**CHARLOTTE - MECKLENBURG
PLANNING COMMISSION**

SUBJECT: Administrative Approval for Petition No. 97-25 Seaboard Realty, Inc. Tax Parcel # 047-271-03

UNIVERSITY PLACE PARCEL X FOR SEABOARD REALTY, INC.

TECHNICAL DATA SHEET FOR PUBLIC HEARING PETITION NO. 97-25

ILLUSTRATIVE PLAN FOR PUBLIC HEARING PETITION NO. 97-25

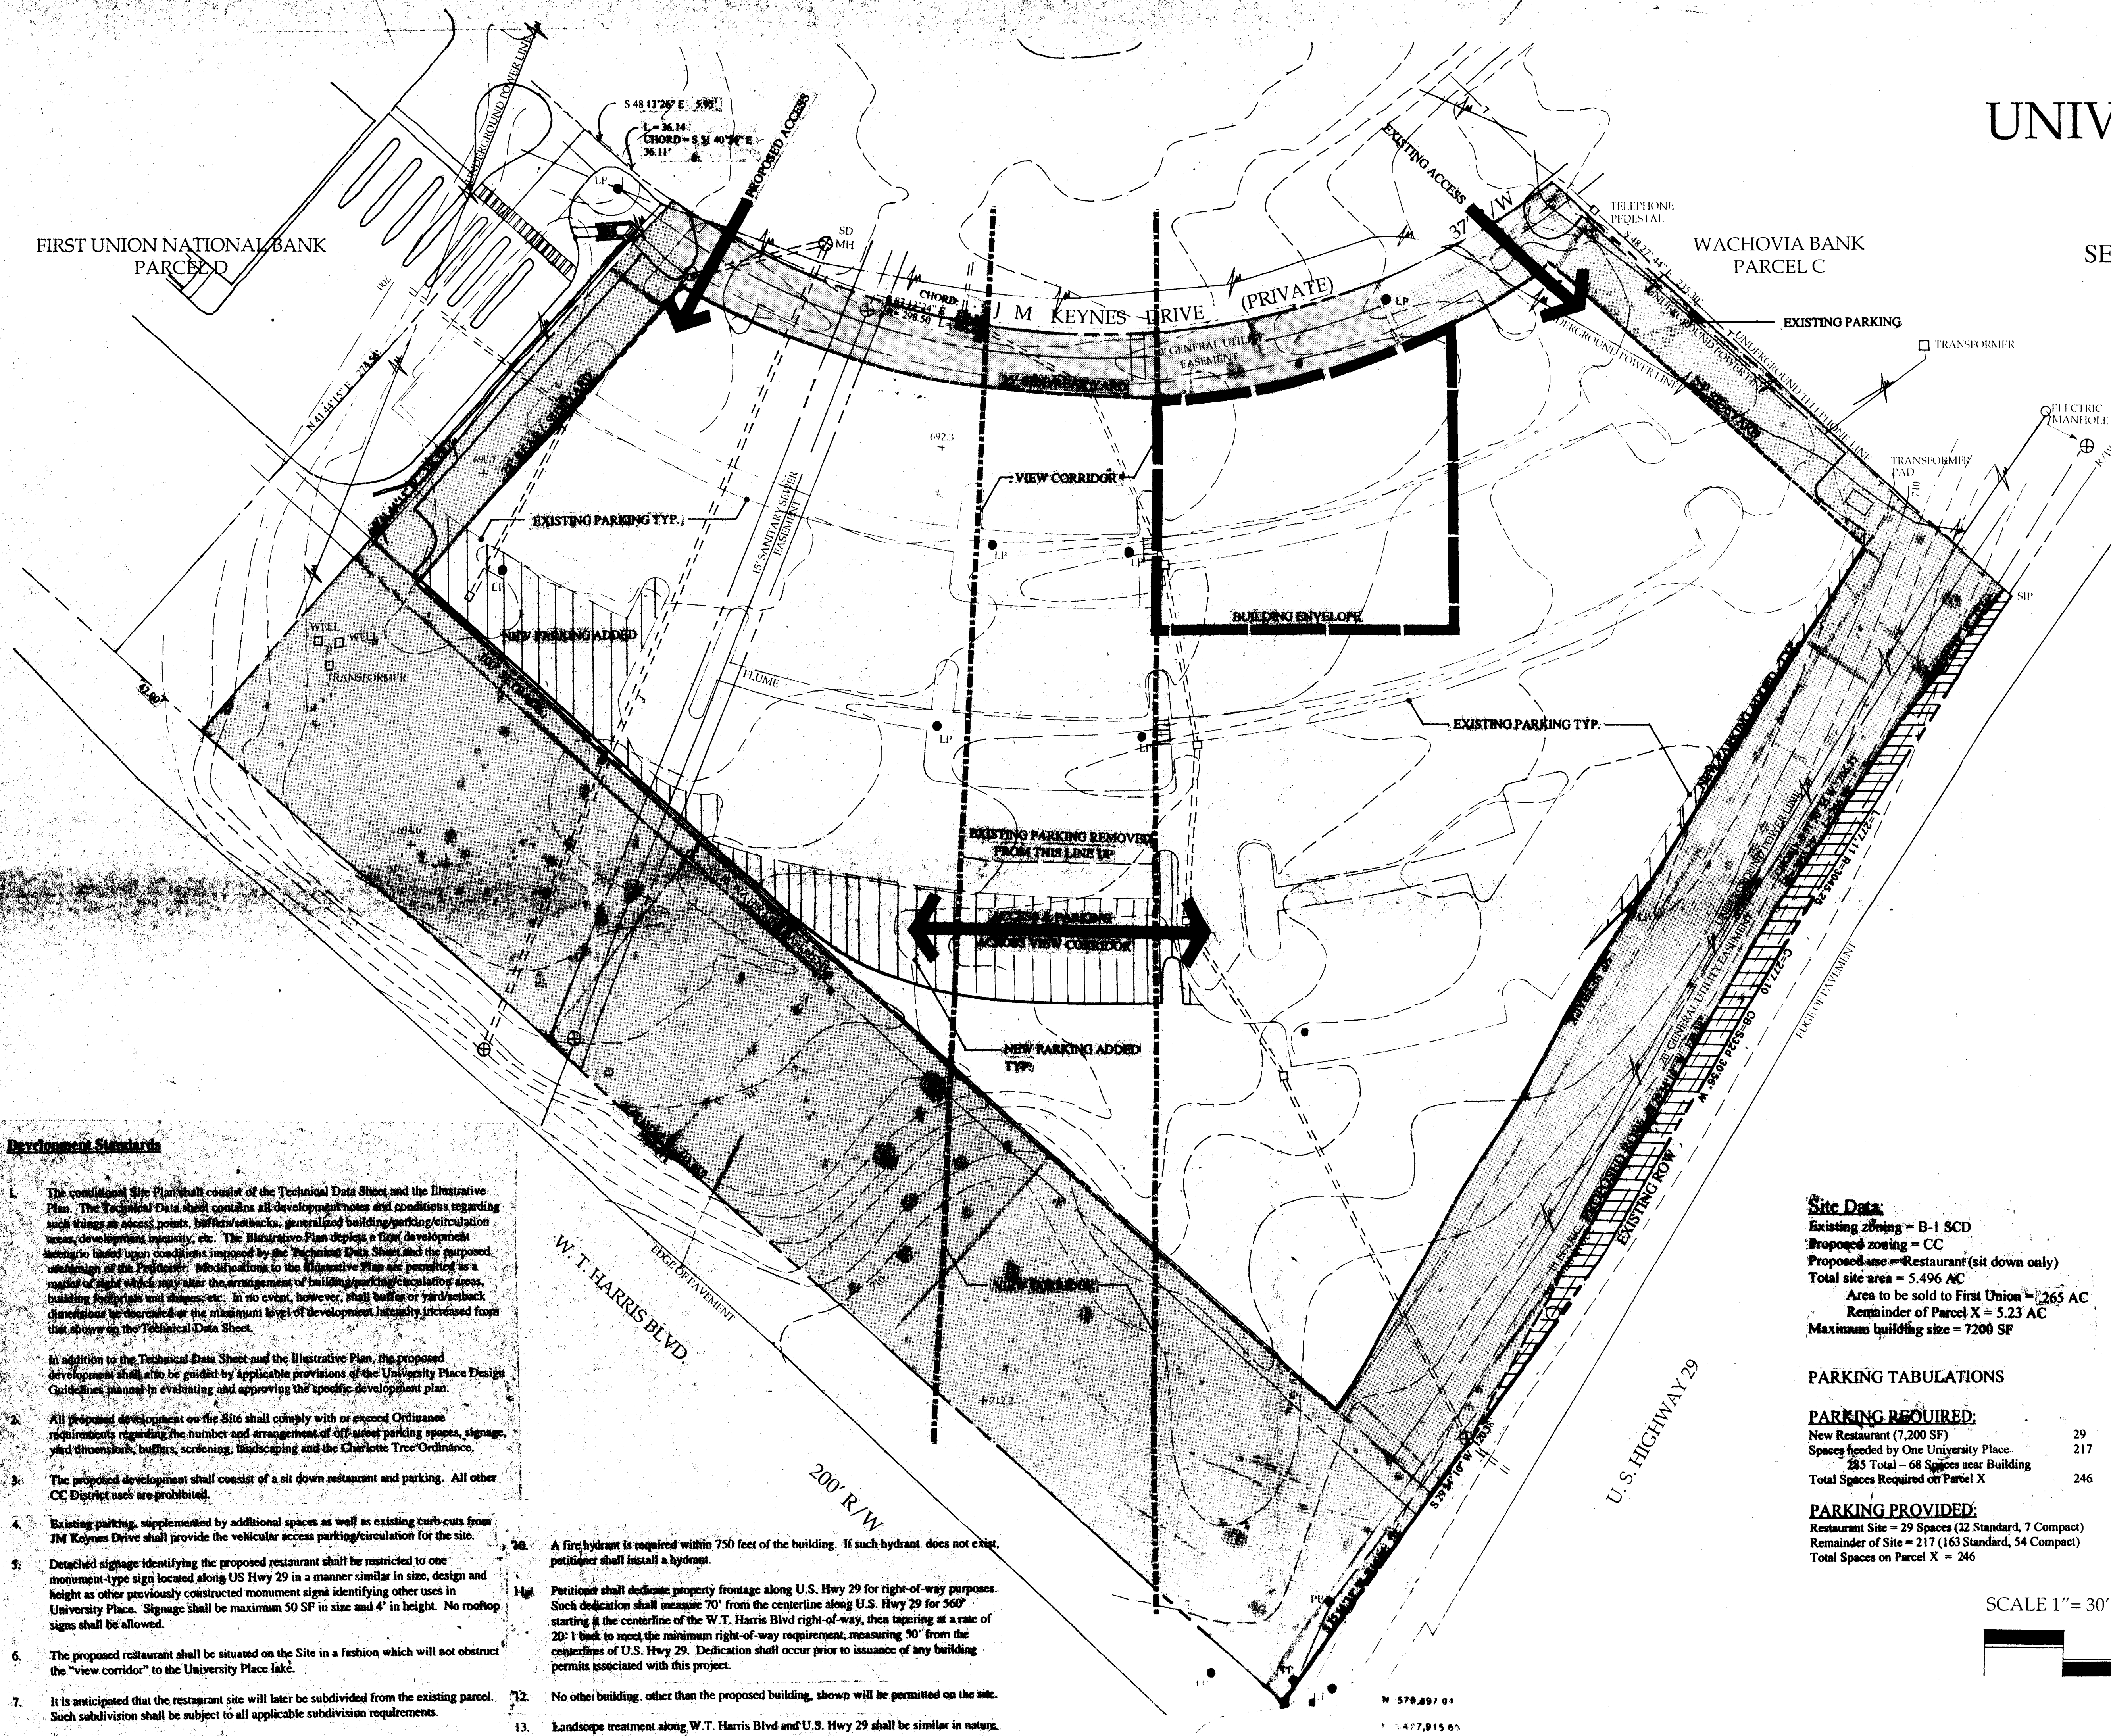
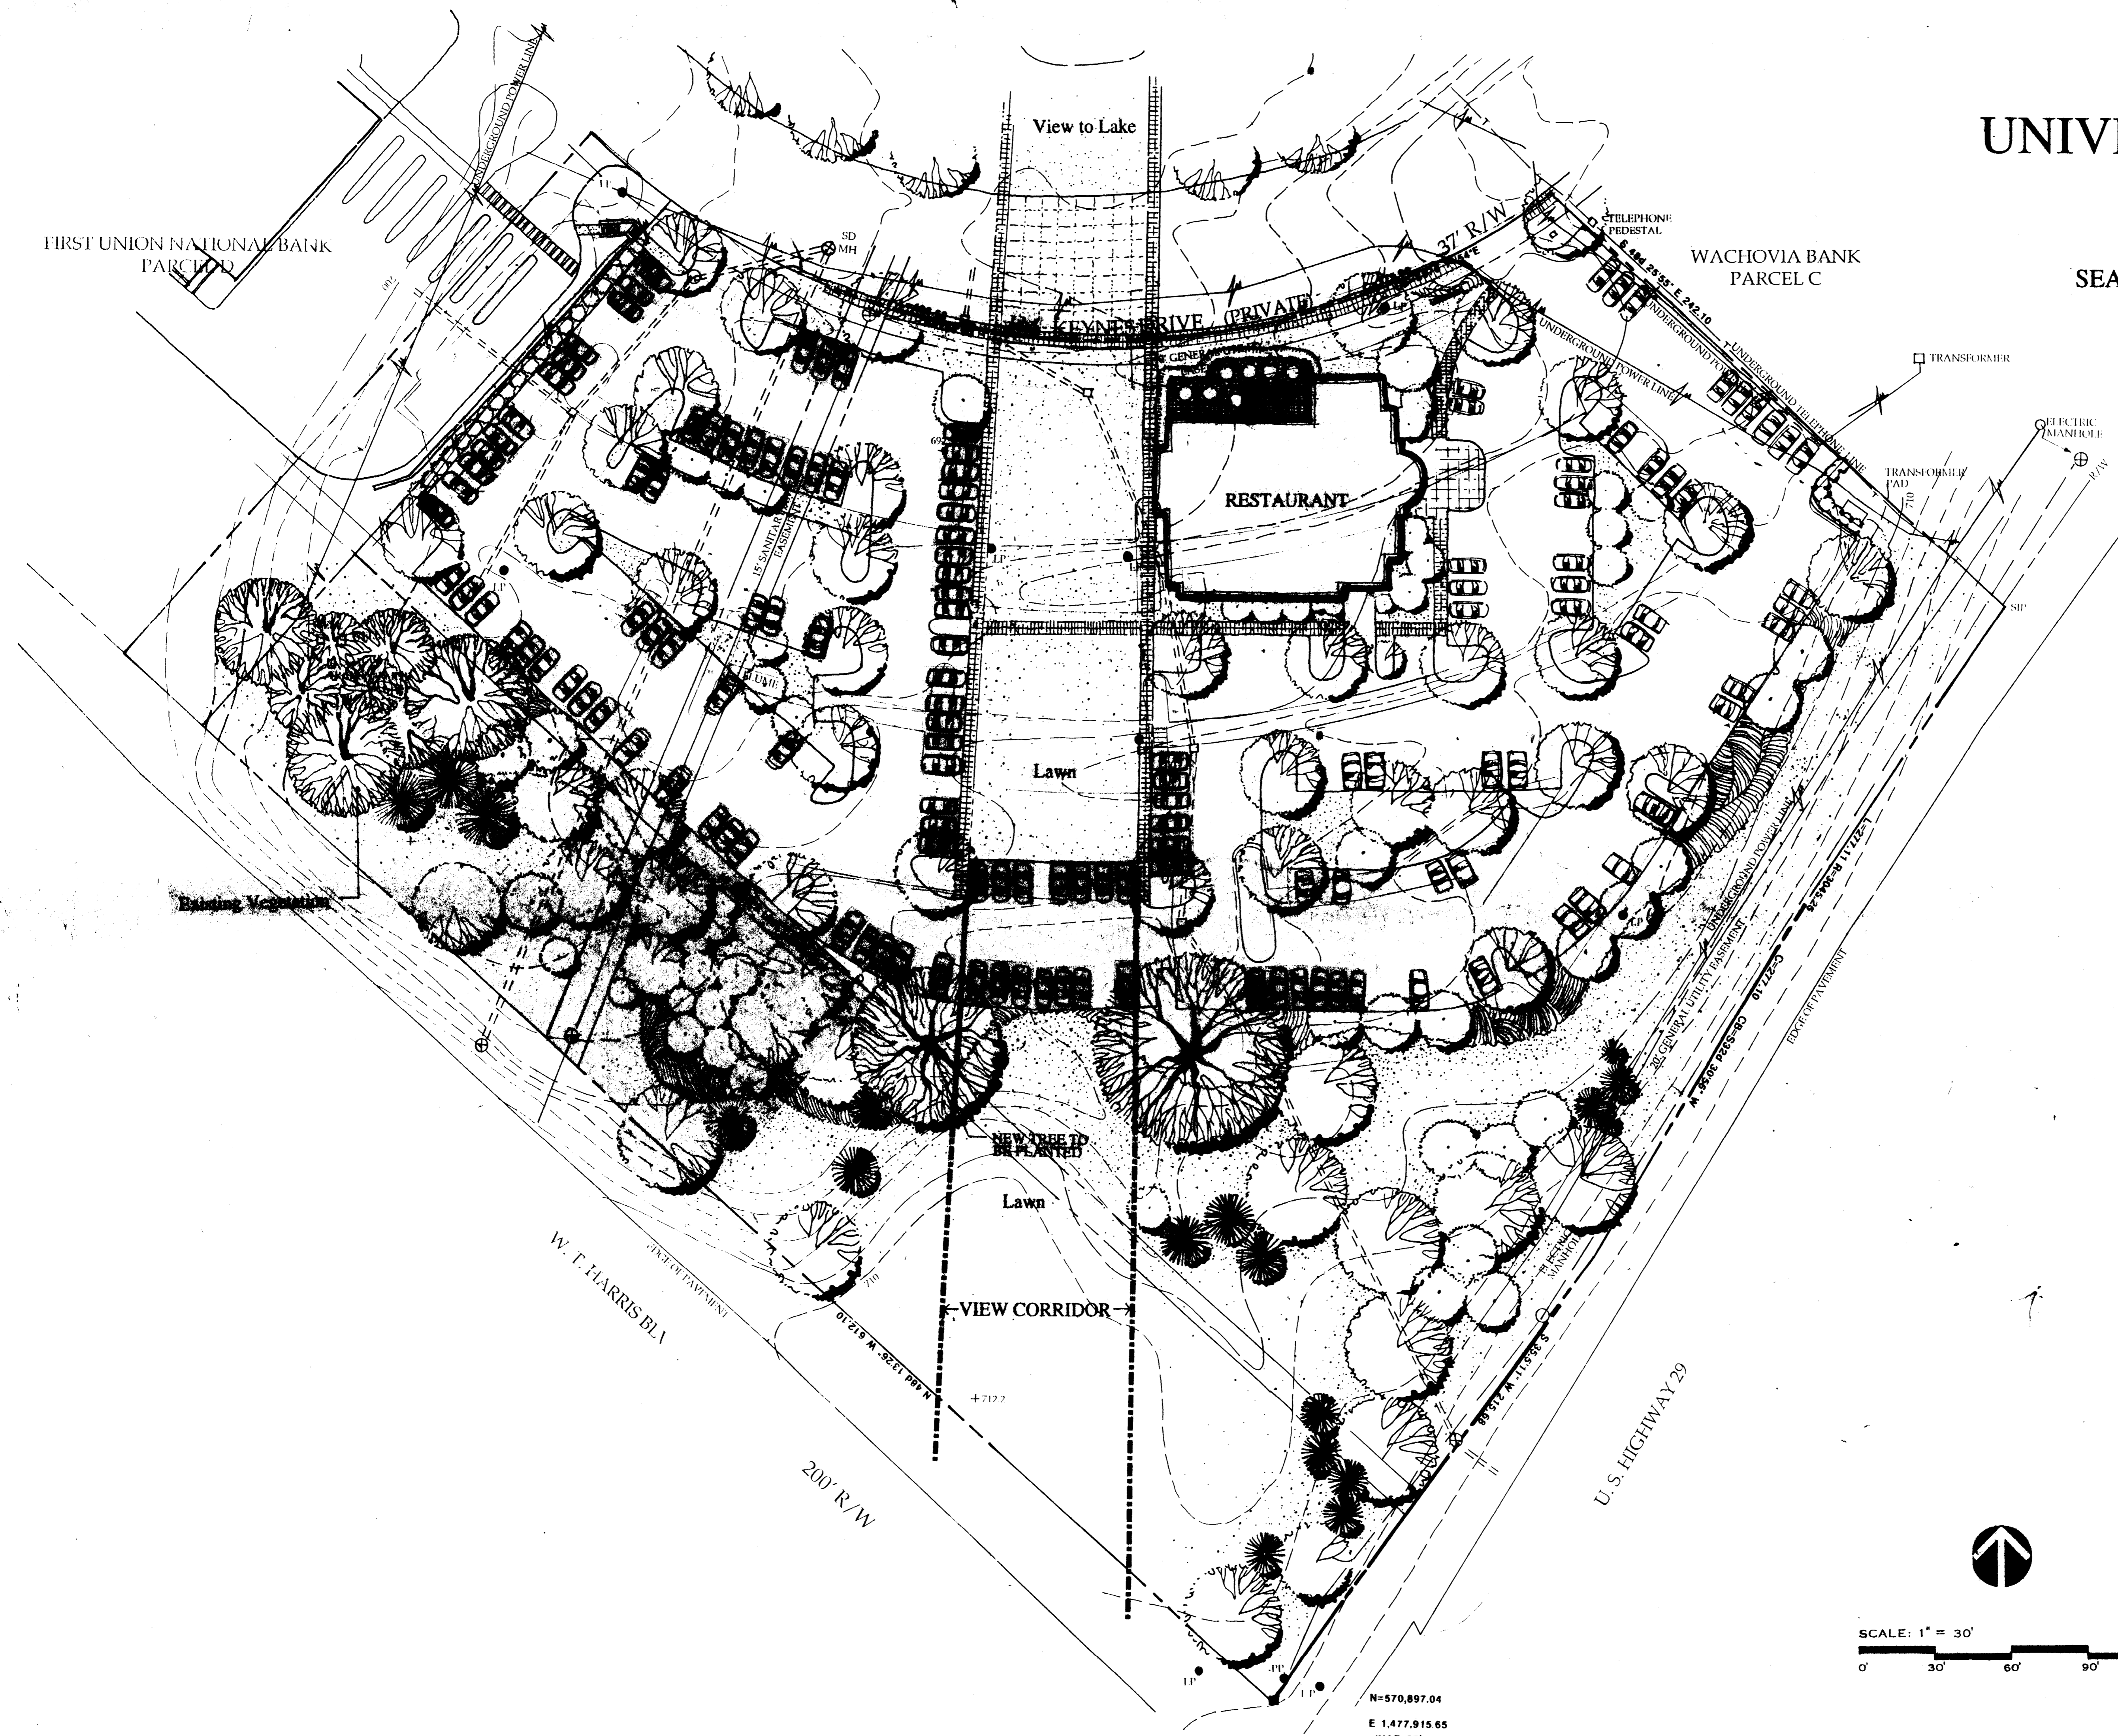
Attached is revised plan for the above mentioned rezoning petition. The plan has been revised to allow a portion of the site along the Western property line to be sold to First Union National Bank for the expansion of there existing drive-thru windows. The revised plan maintains the required yards and the required number of parking spaces within parcel "X". Since this change is minor and does not intensify development on the site we are administratively approving this revised plan. Please use this revised plan when evaluating requests for building permits and certificates of occupancy.

FIRST UNION NATIONAL BANK
 UNIVERSITY PLACE
 CHARLOTTE, NORTH CAROLINA
 DRIVE-THROUGH EXPANSION
 SITE PLAN

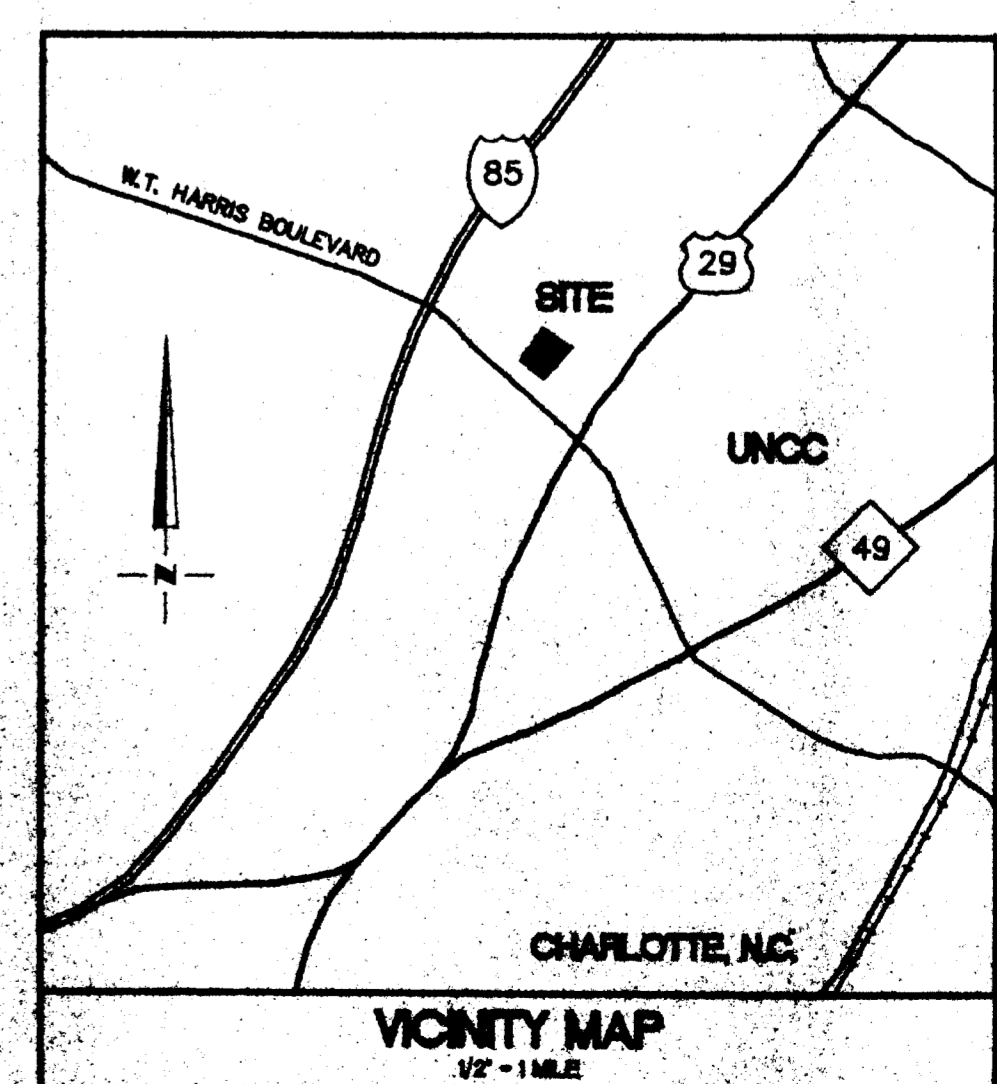
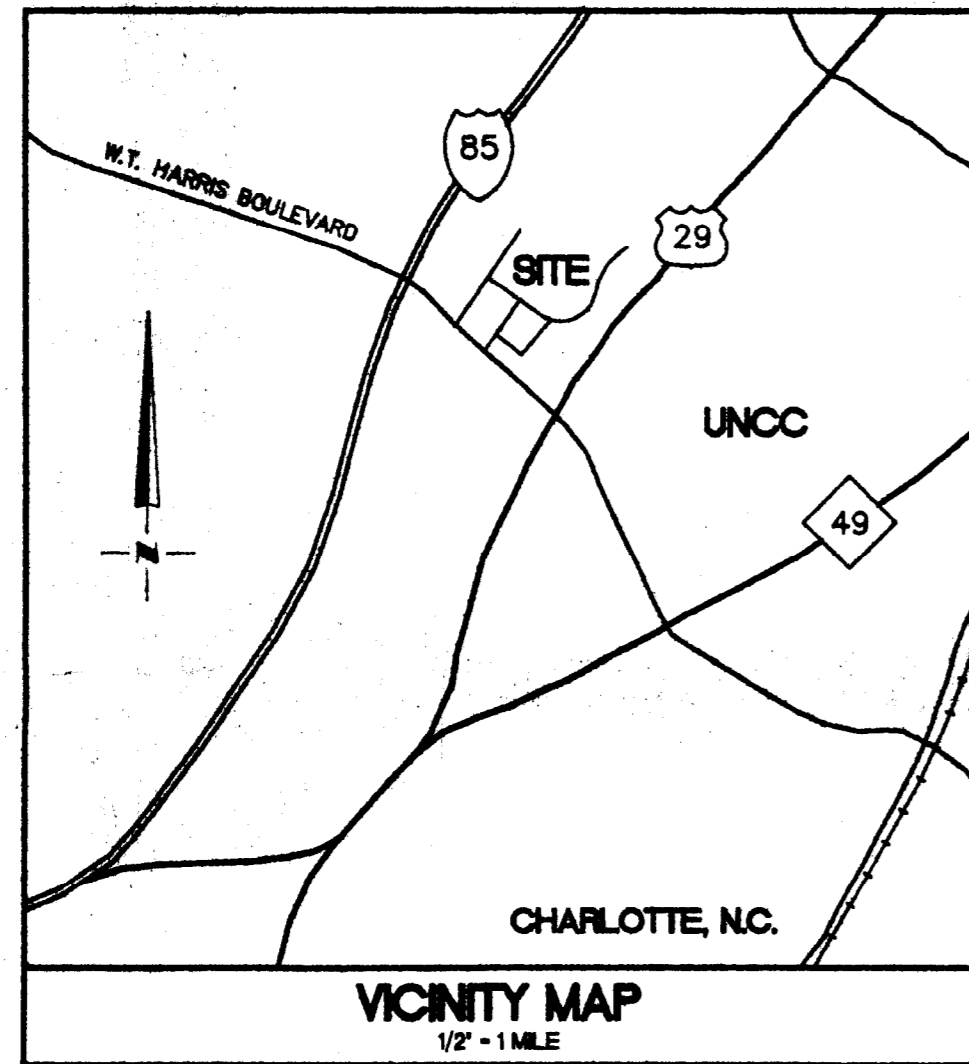
DESCRIPTION OF CHANGES

- △ ADDITION OF WALL, RELOCATION OF STAIRS, ADDED 4 PARKING SPACES
- △ REALIGNMENT OF PARKING SPACES AT BOTTOM OF WALL
